February 24, 2010

Re: James Monroe Middle School New Track and Field Grading and Drainage Plan

Engineer's Stamp dated 1-18-10 (B10/D004)

SHEET TITLE
OVERALL
GRADING
&
DRAINAGE
PLAN

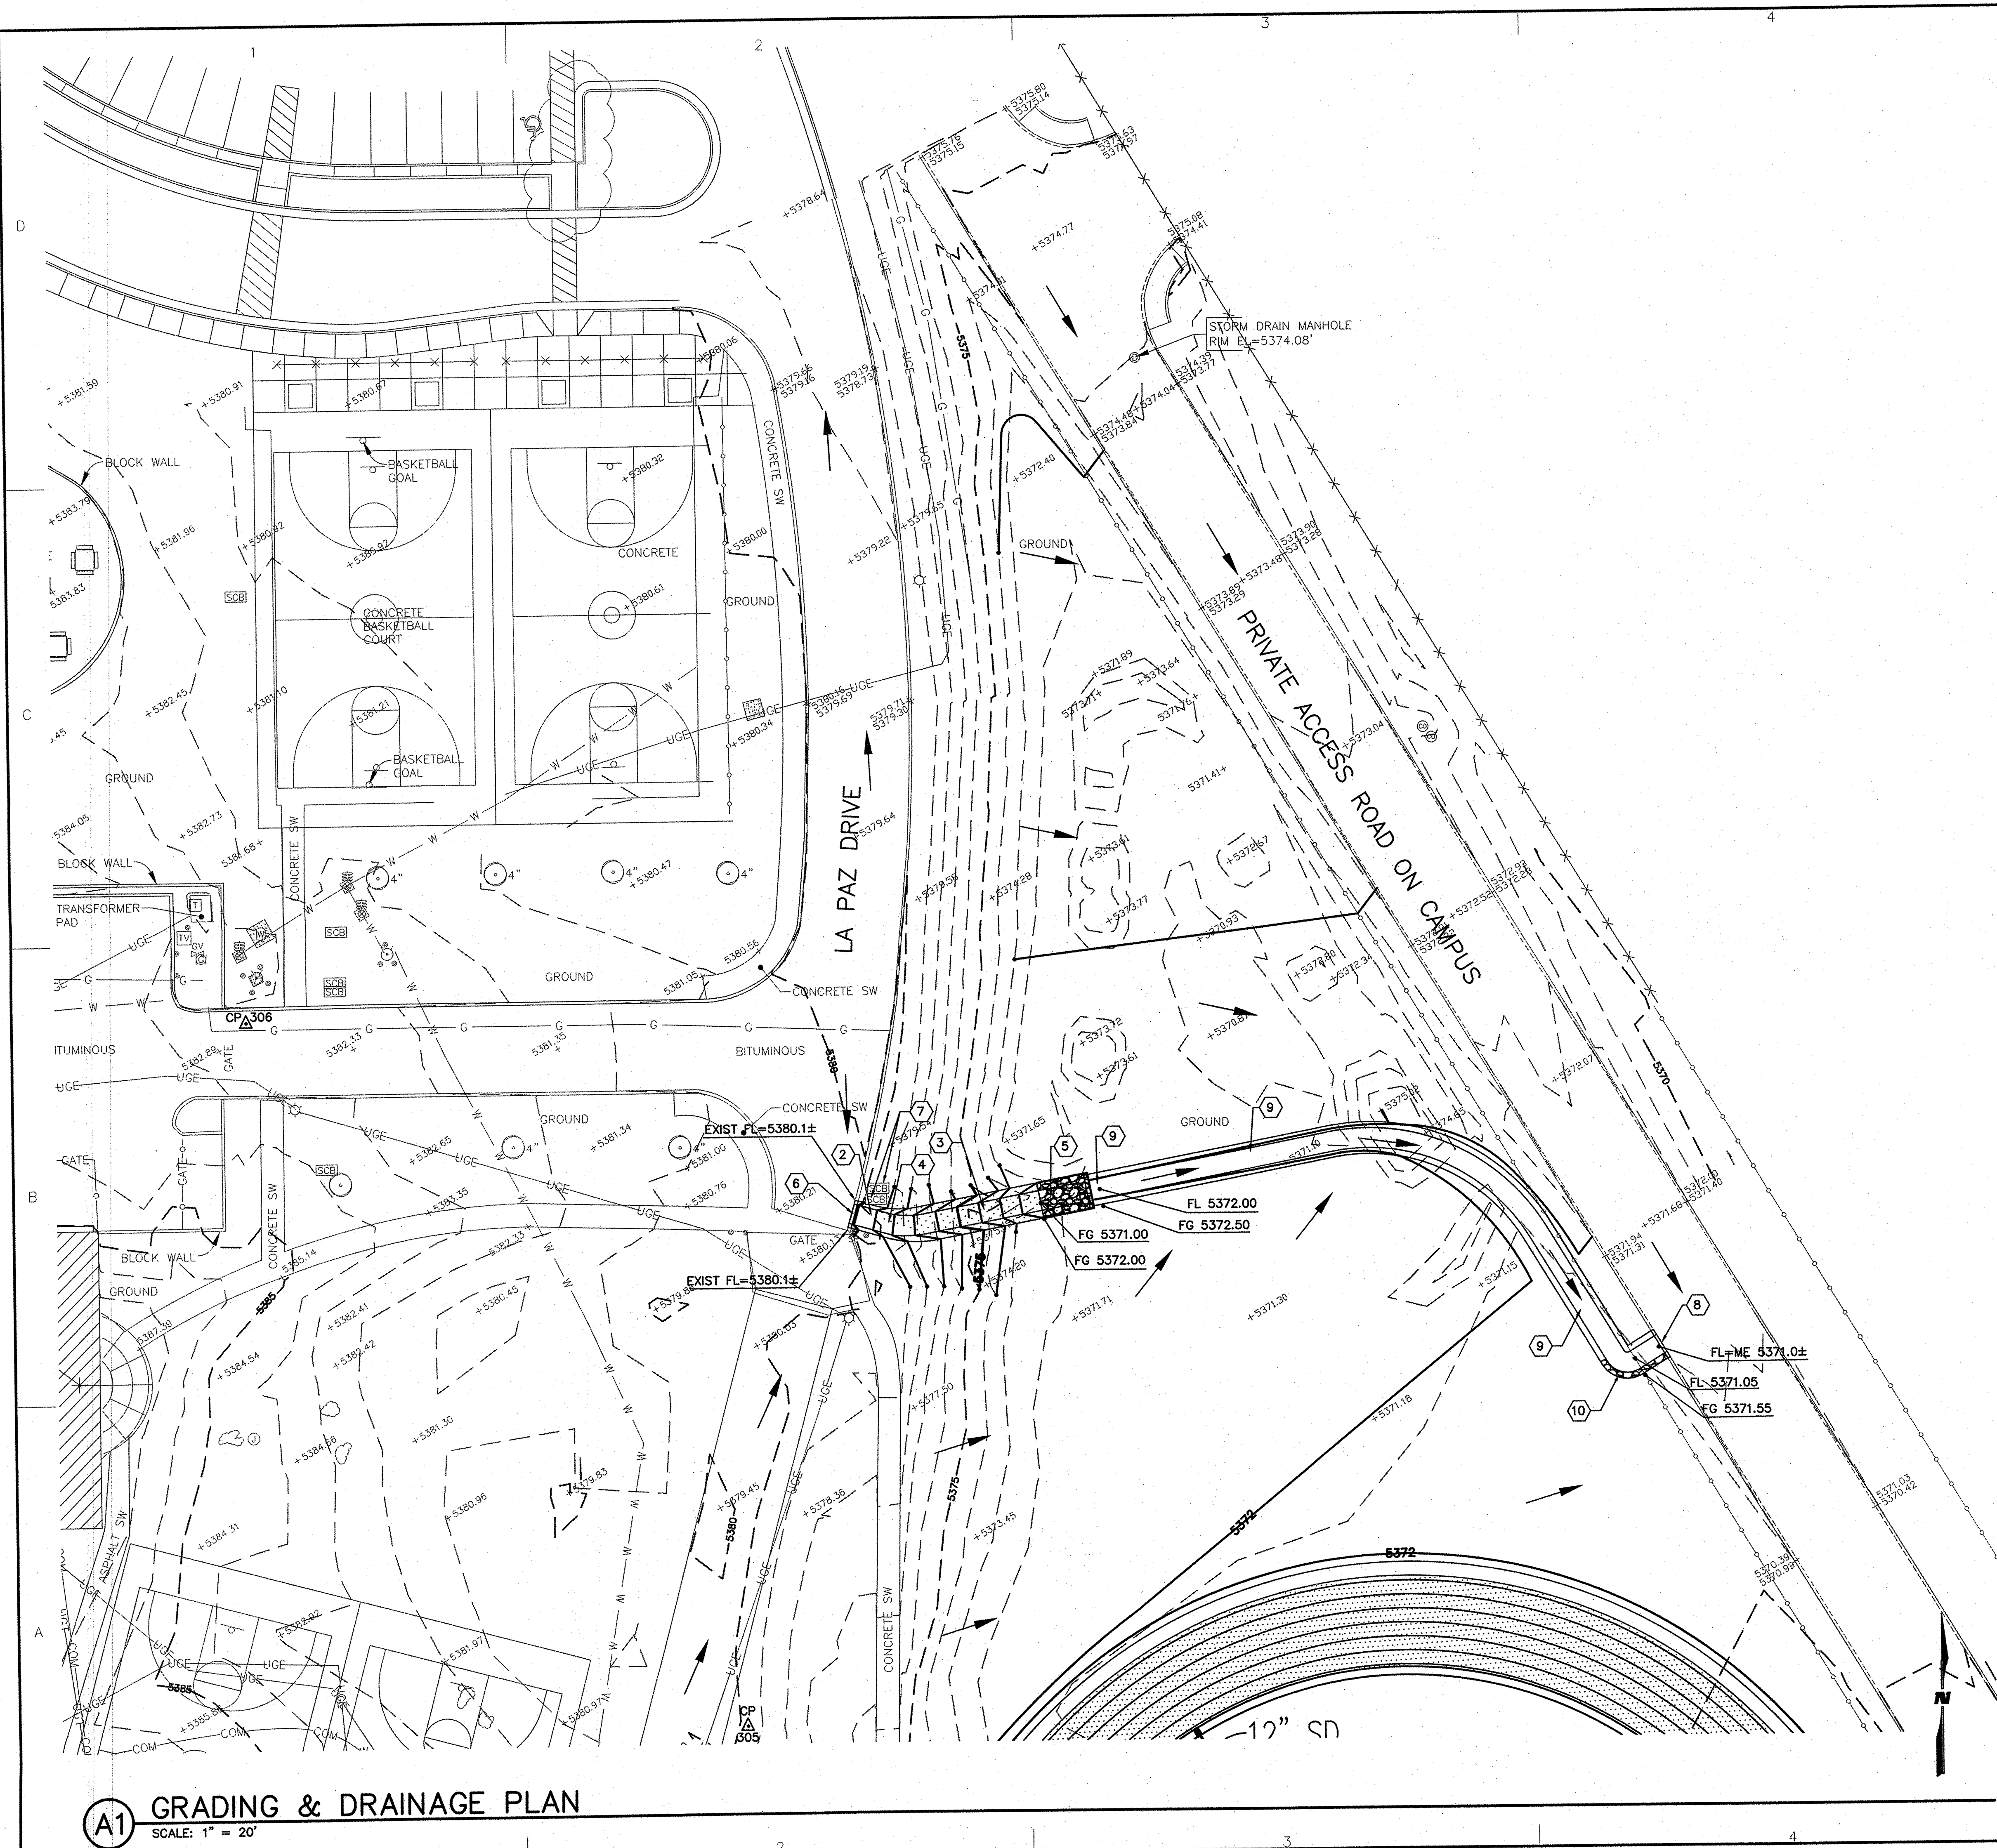
You may want to provide some means of erosion control on the slope around the south side of the track.
